Lea Castle Farm, Wolverley, Kidderminster

Stage 1 Road Safety Audit

Reference: PC1790-RHD-ZZ-XX-RP-X-0001

PROPOSED MINERAL SITE AT LEA FARM, WOLVERLEY, WORCESTERSHIRE - DESIGNER'S RESPONSE TO STAGE 1 ROAD SAFETY AUDIT

Extract from The Hurlstone Partnership drawing 'Figure 1', showing pedestrian desire line across the junction

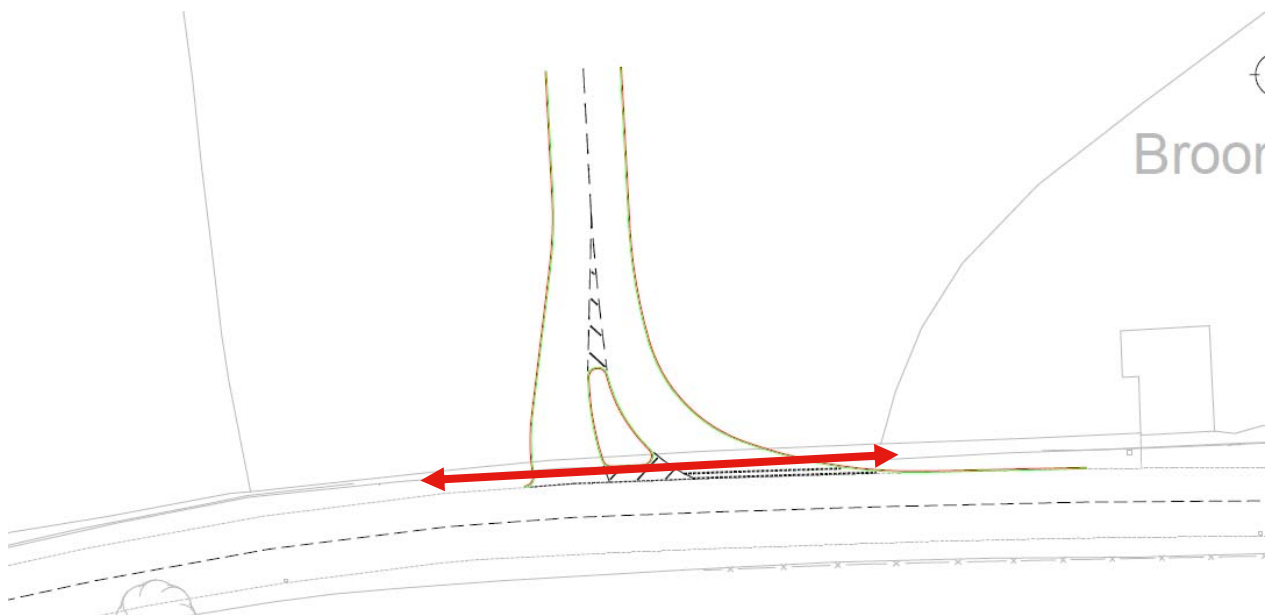
Location: B4189 Wolverley Road/ proposed site access, existing footway.

Summary: Failure to consider pedestrian movement across the junction could lead to pedestrian trips/falls at the kerb face, resulting in injury or collisions with vehicles on the main road.

Description: The proposed access drawing does not provide any pedestrian facilities across the new junction. The width of the junction could result in pedestrians crossing in two movements, waiting either within the hatched markings to the south of the traffic island (at risk of collisions with vehicles on the main road), or on the island itself.

No information has been provided to the Audit Team in relation to the provision of dropped kerbs on the footway approaches to the junction or on the traffic island. Failure to consider pedestrian movement across the junction could lead to pedestrian trips/falls at the kerb face, resulting in injury or collisions with vehicles on the main road.

Provide dropped kerbs and space within the central island for pedestrians to wait safely.

The central island within the site access bellmouth is set-back to a position coincident with the rear of the existing footway, such that the existing desire line and established pedestrian route may be retained. The provision of dropped kerbs at the crossing point, together with tactile pavings to assist the visually impaired, are recommended and will be incorporated into the detailed design package to be submitted for approval and Stage 2 RSA, following the granting of planning permission, in accordance with the normal procedures.

| PROBLEM LOCATION PLAN | LEA CASTLE FARM, WOLVERLEY STAGE 1 ROAD SAFETY AUDIT |

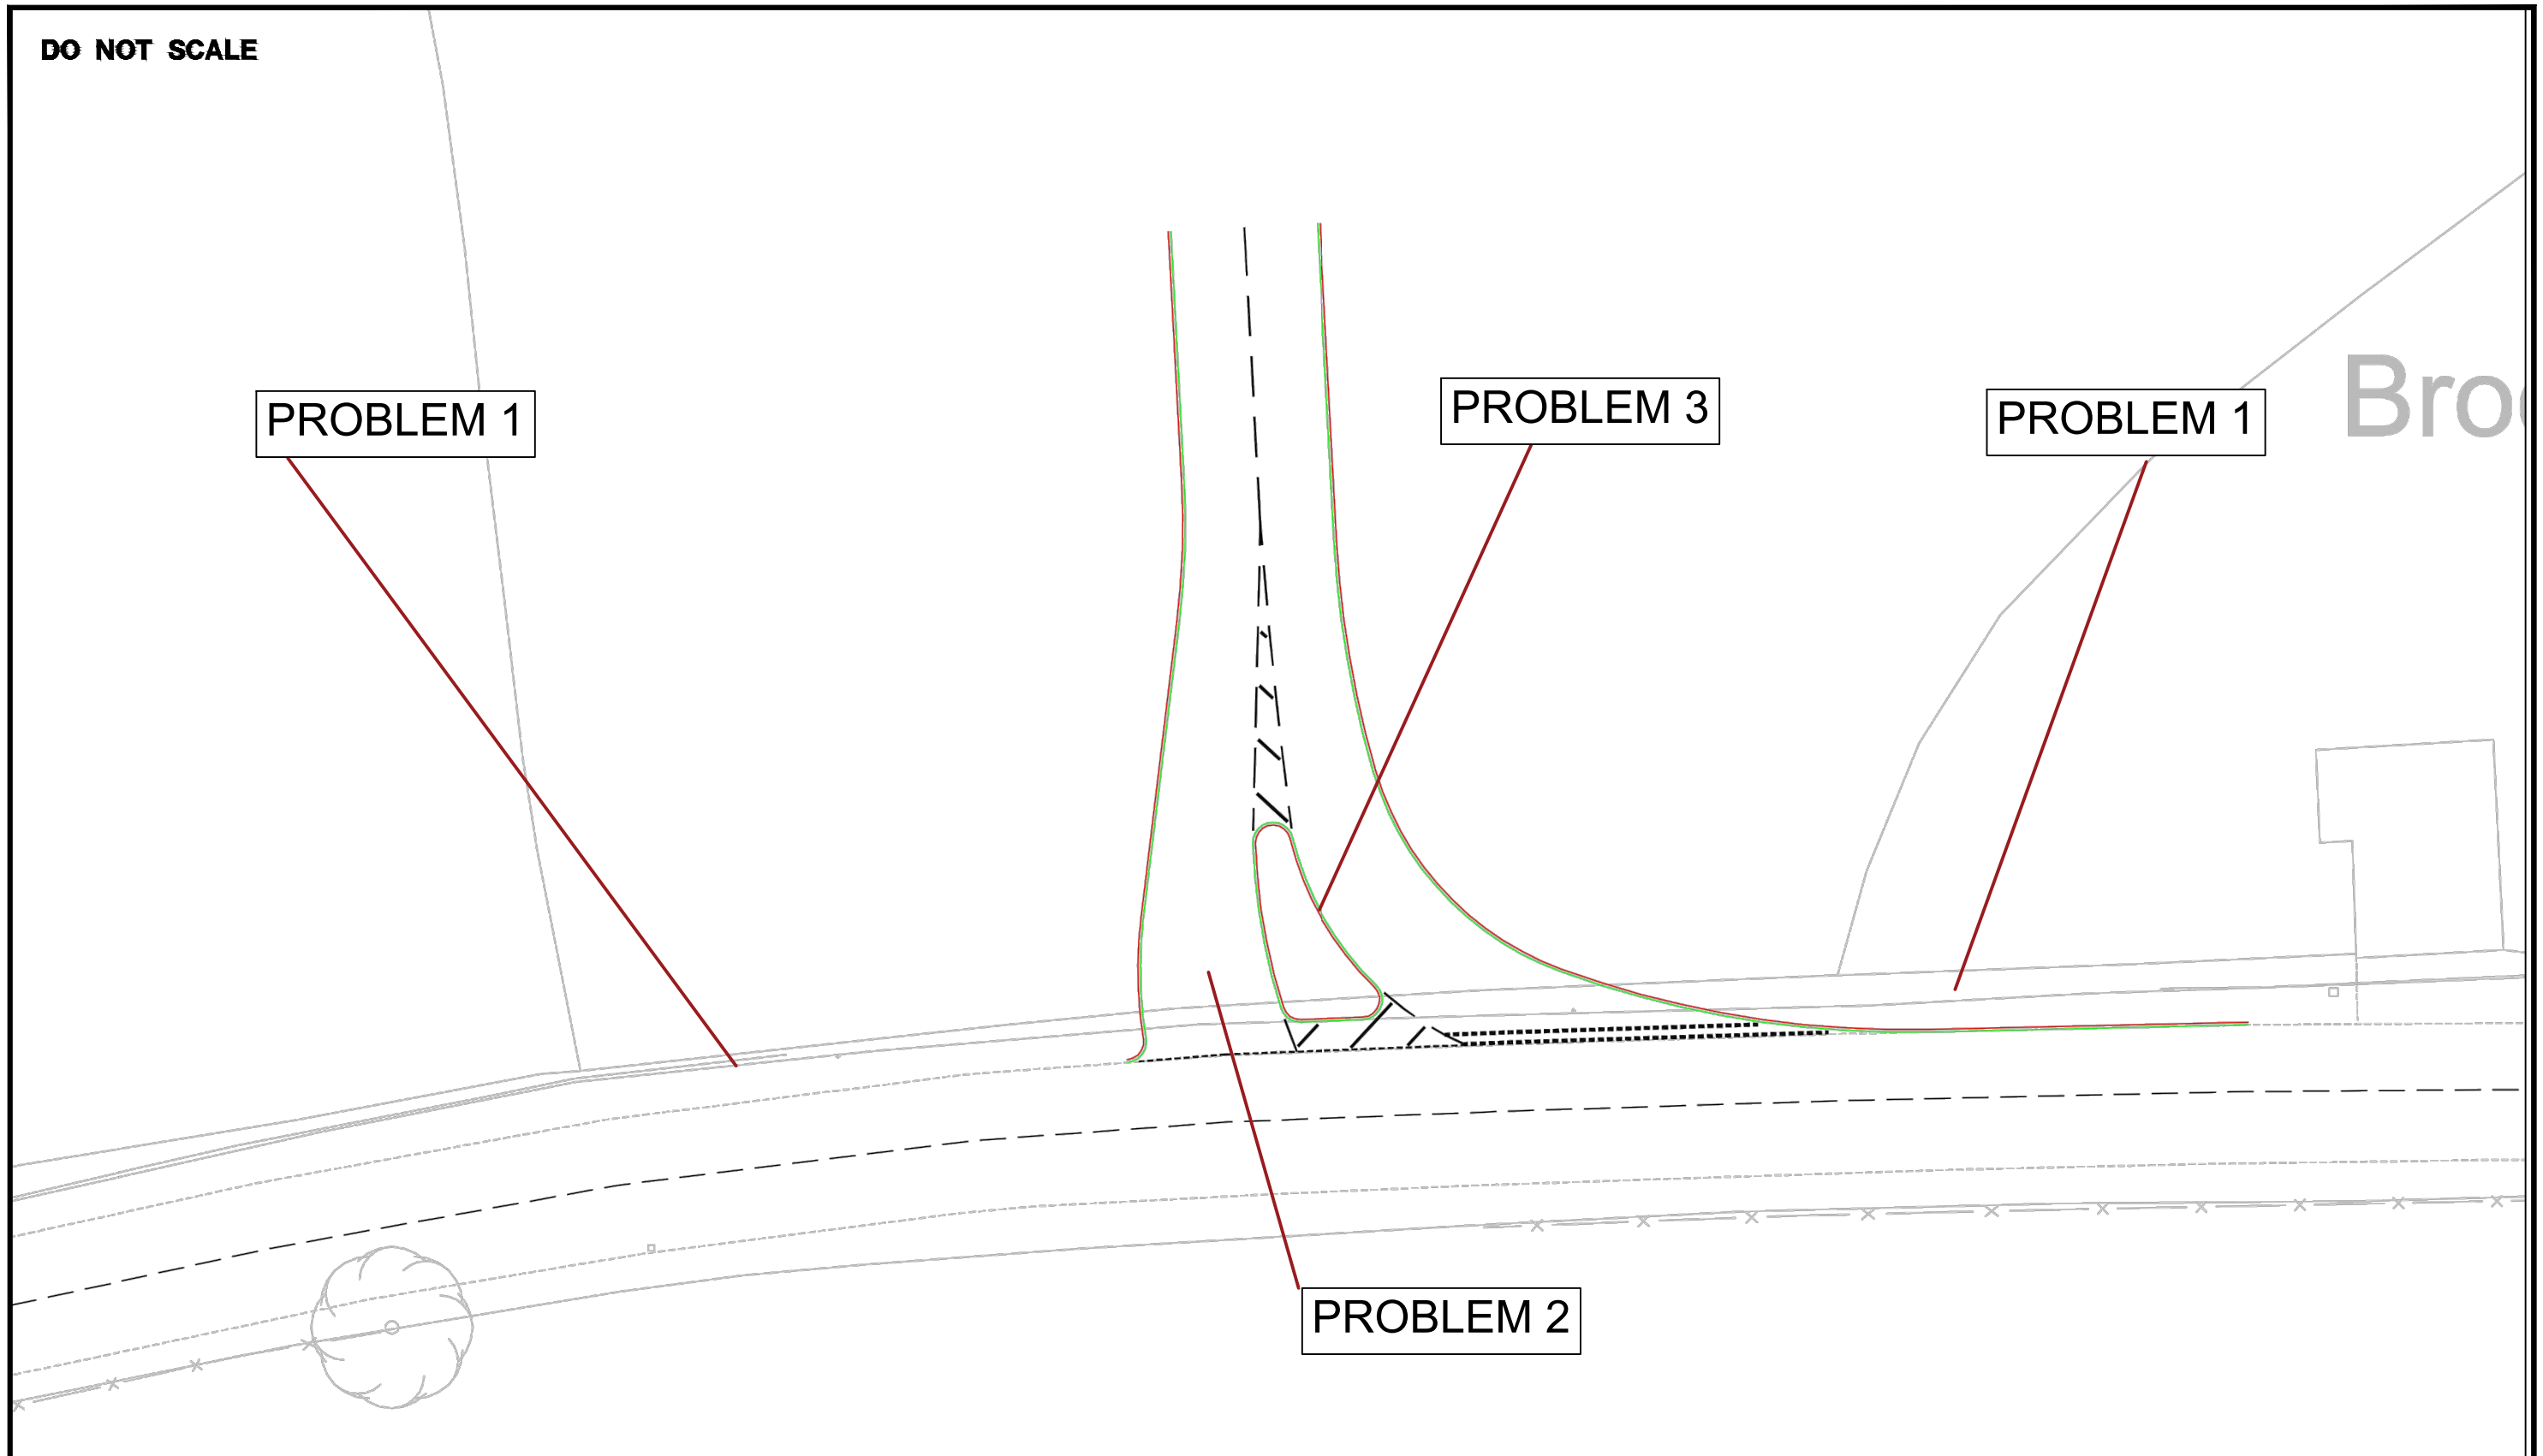
Summary: Exposed termination of the removed section of the existing brick wall could result in a higher severity of injury in the event of a collision.

Description: A section of the existing brick wall is to be removed to accommodate the proposed access and required visibility splays. No detail has been provided to the Audit Team on the method of termination of the exposed sections of the wall. Failure to provide adequate measures to protect the exposed ends of the wall from vehicle strikes could lead to a higher severity of injury should a collision occur.

Summary: Vehicles turning left into the site could overrun the adjacent footway, resulting in the potential for collisions with pedestrians at the kerb face.

Vehicles turning left into the site could overrun the adjacent footway, resulting in the potential for collisions with pedestrians at the kerb face.
